Public Works (1898) Department.

RAILWAY BRANCH.

G.O., No. 75 R

Record Racks

Plan of Record rack

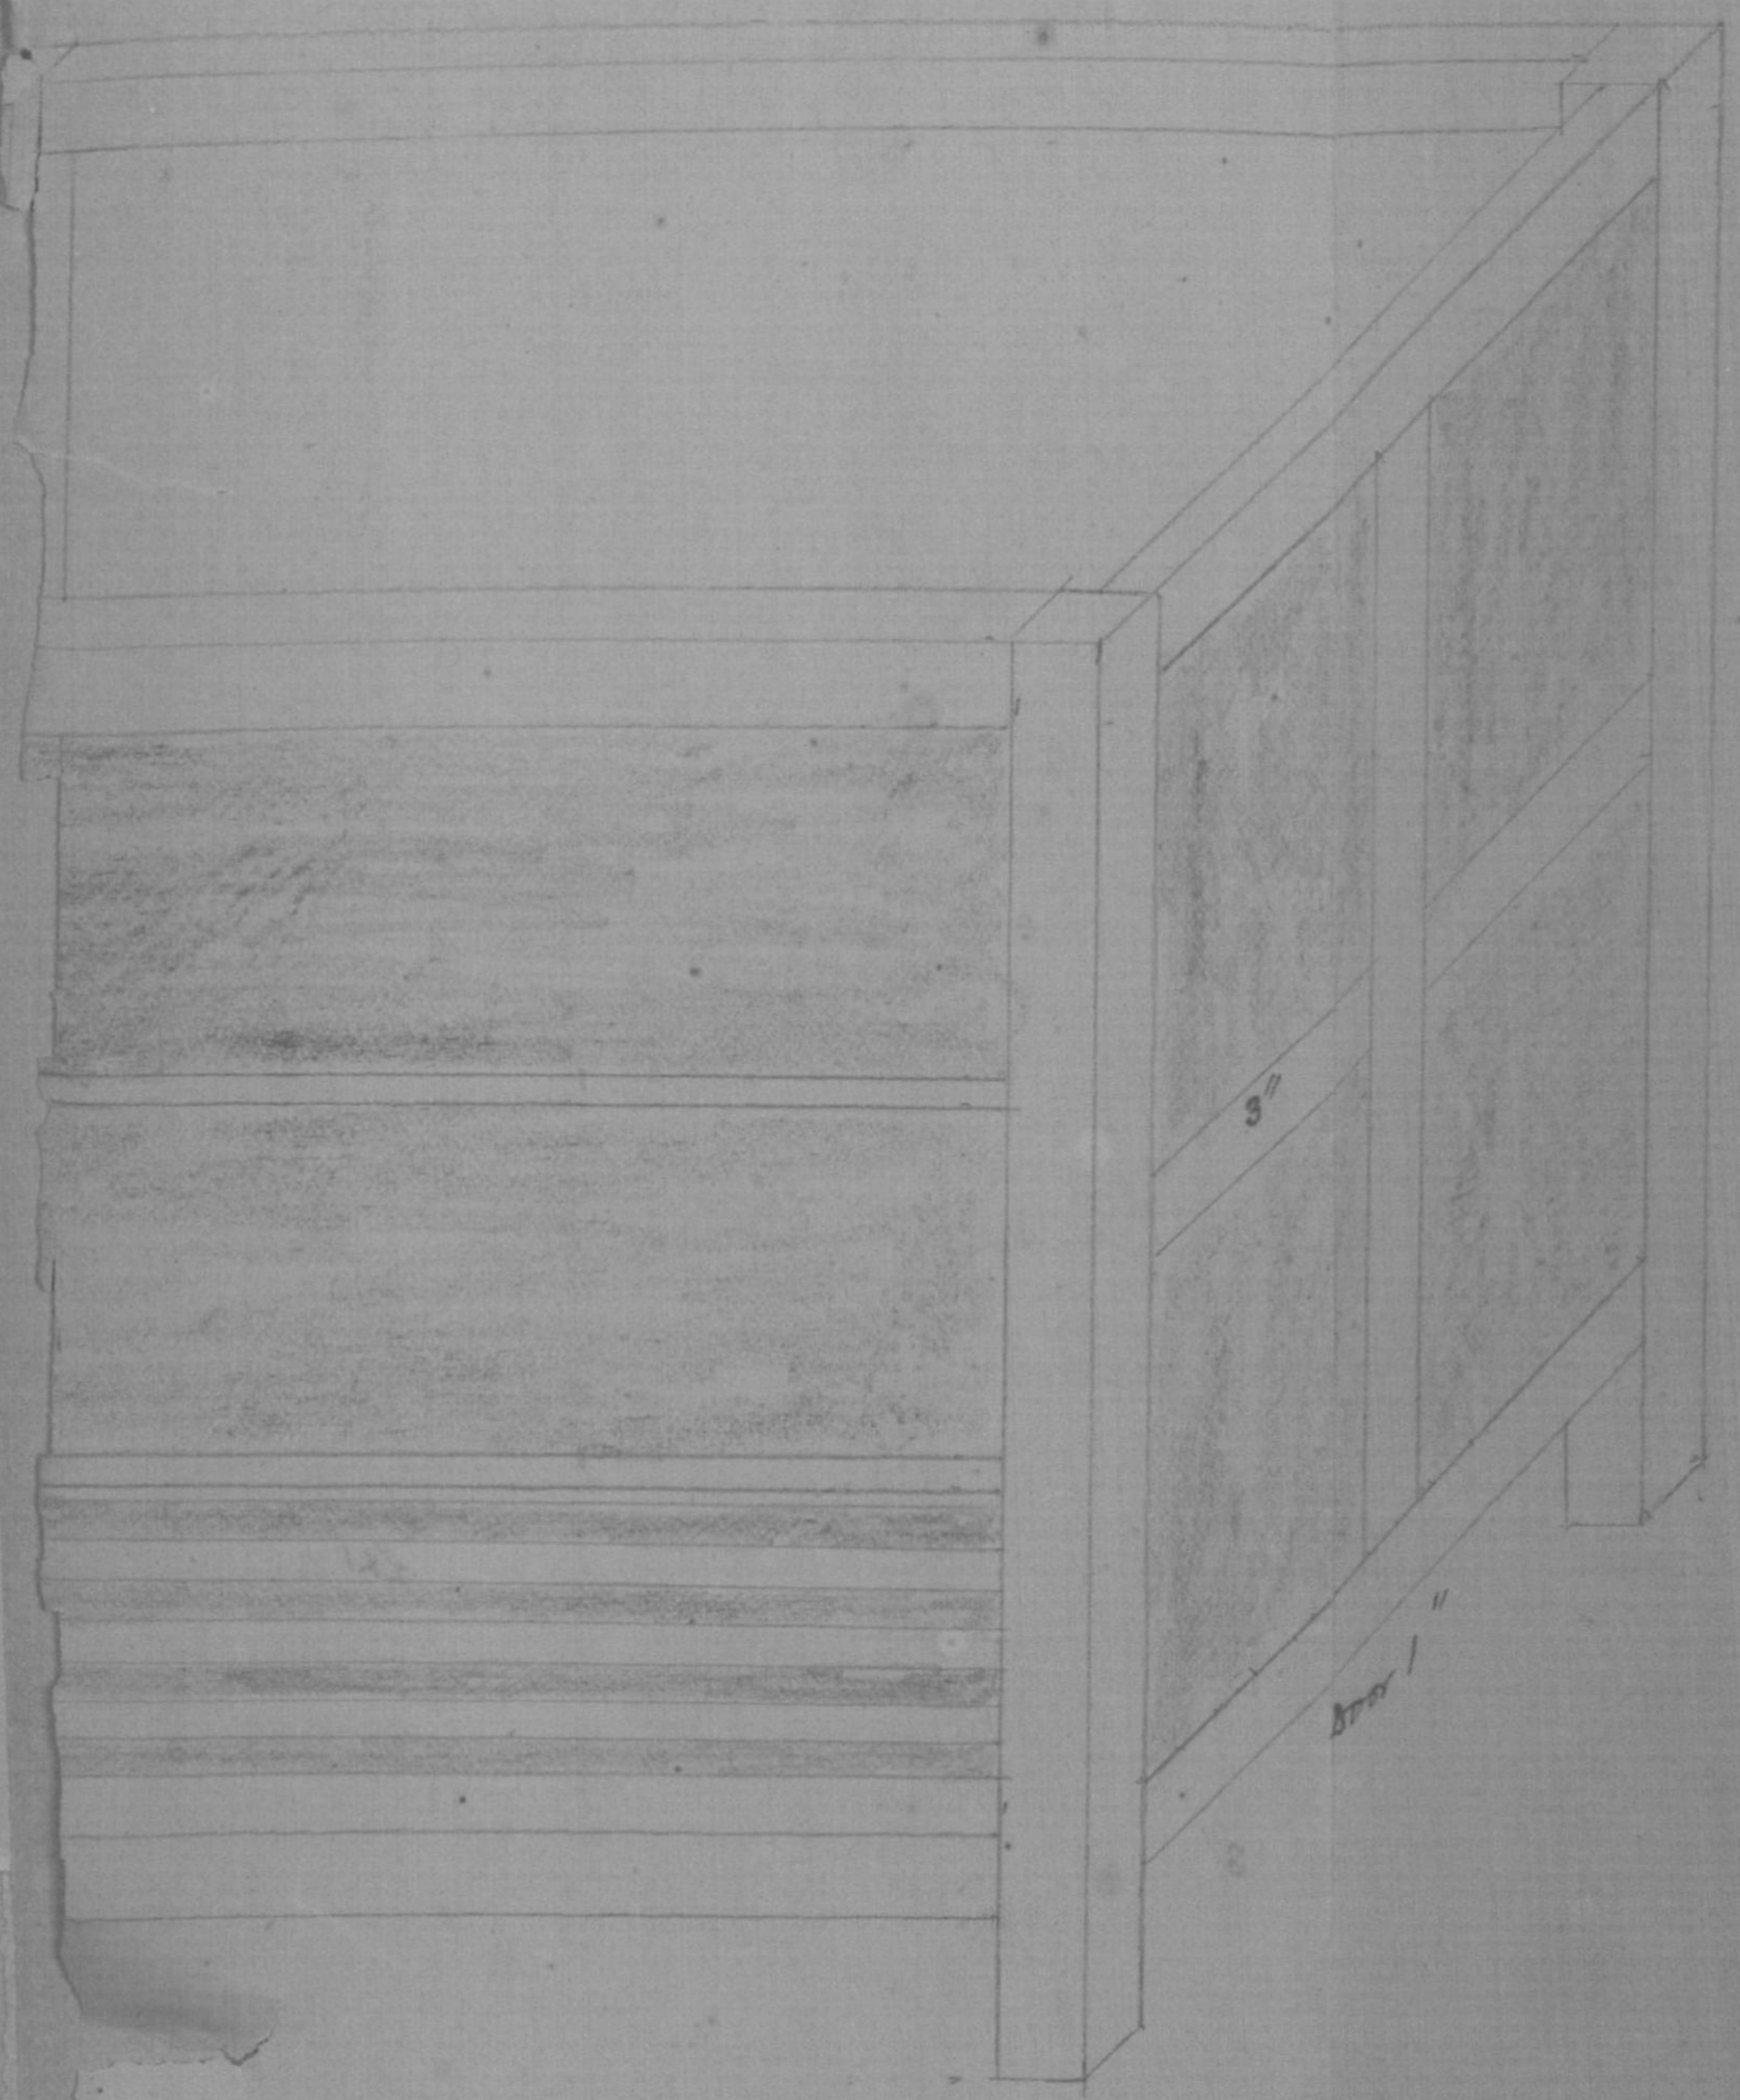
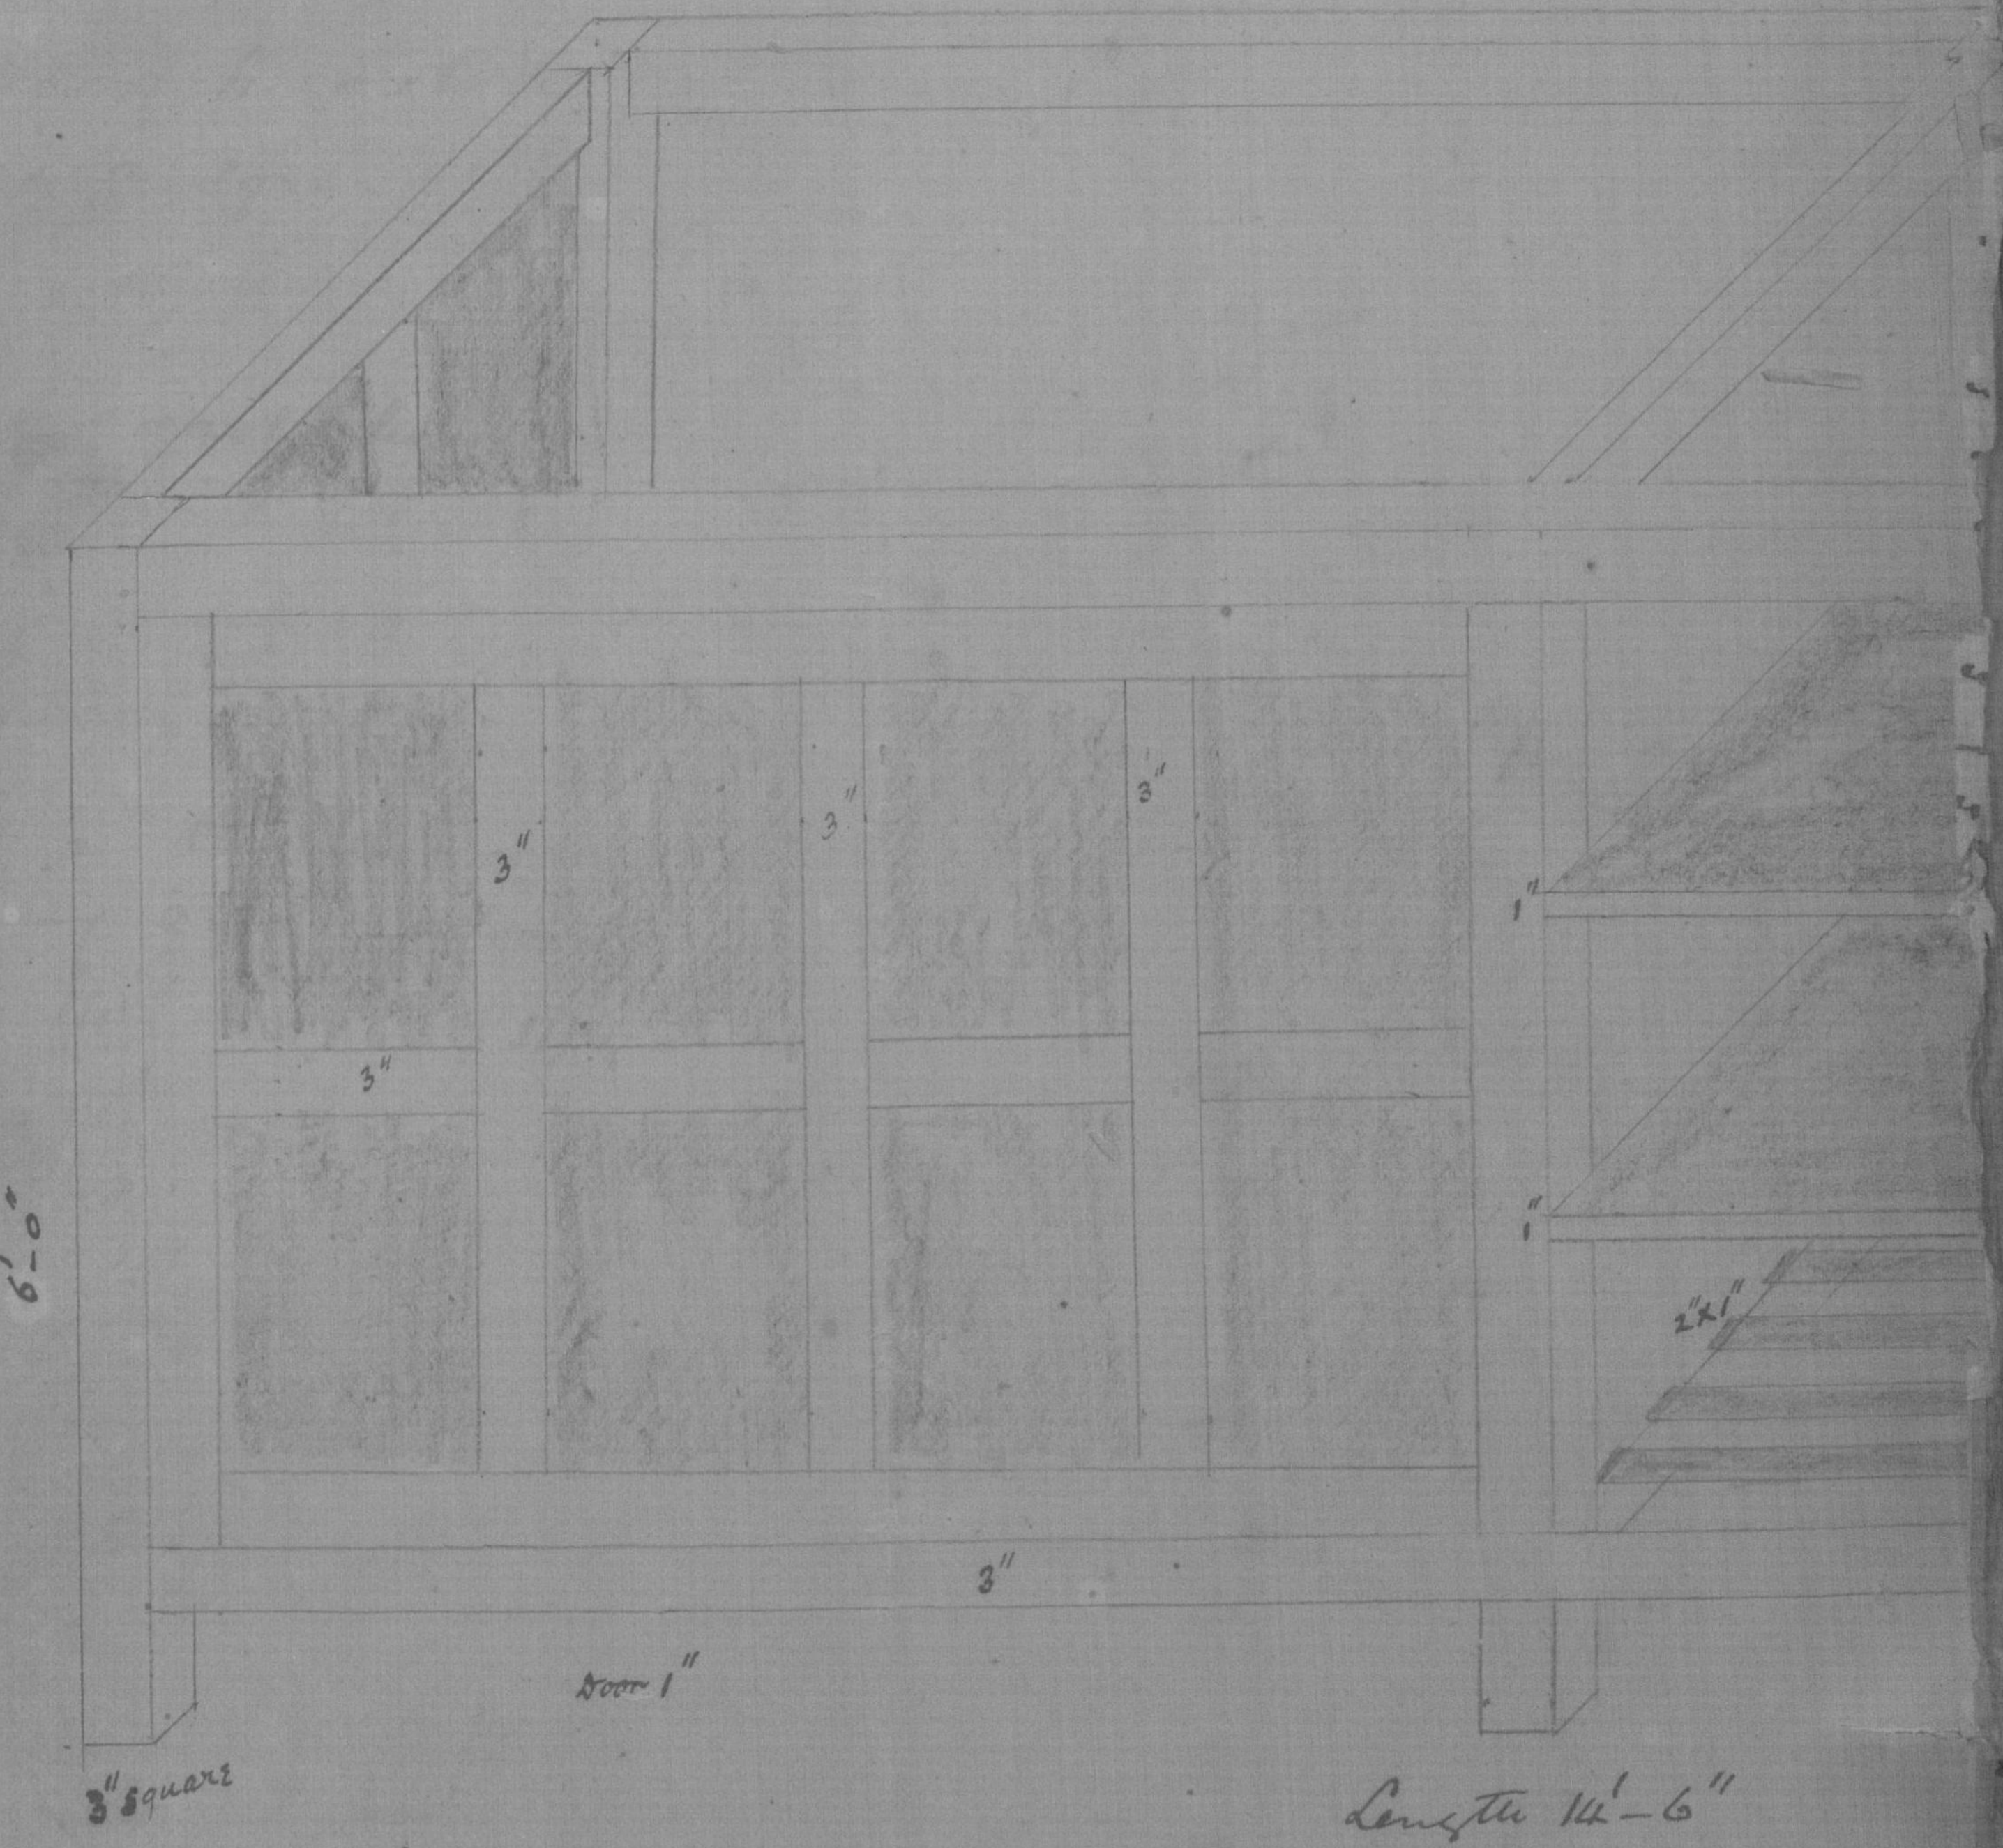
Your plans & estimate are not clear, please state the thickness of planks for items 2 & 3.

× Amount of labour cannot be checked.

I really cannot examine the estimate & plan which are very vague. However, from the rough description given, I think Rs 49 is ample.

* Amount of labour cannot be checked.

Length 14'-6"
Height ~~Breadth~~ 6'-0"
Breadth - 2'-9"

Rs. As. P
6 posts 3" Square Each 1 Re } ... =	5-10-" ~~6. 0. 0~~
2¼ cft @ 2½ as per cft	
2 planks for Shelves 14½ length 2¾ ft wide 1" thick } =	20-"-" ~~24. 0. 0~~
=79¾ or Say 80 sft @ 4 as sft	
Top & bottom frame 3" Sqr. at 2½ Rs	— 5. 0. 0
8 planks for sides & 4 frames for both ...	5. 0. 0
Planks for doors including frame	- - 10. 0. 0
2 wheels & Iron bottoms	- - - 3. 0. 0
	48-10-" ~~53-0-0~~
Labour	*10. 8. 0
Total Rs	63-8.0
	59-2-0
~~Deduct [illegible]~~	-7-6
	58-10-6

Herewith a revised plan and a revised estimate for favor of check.

The estimate is fair. It has been cut down to Rs 59.2.. exclusive of the battens at bottom. If this be taken into consideration Rs 63.8.. may be passed
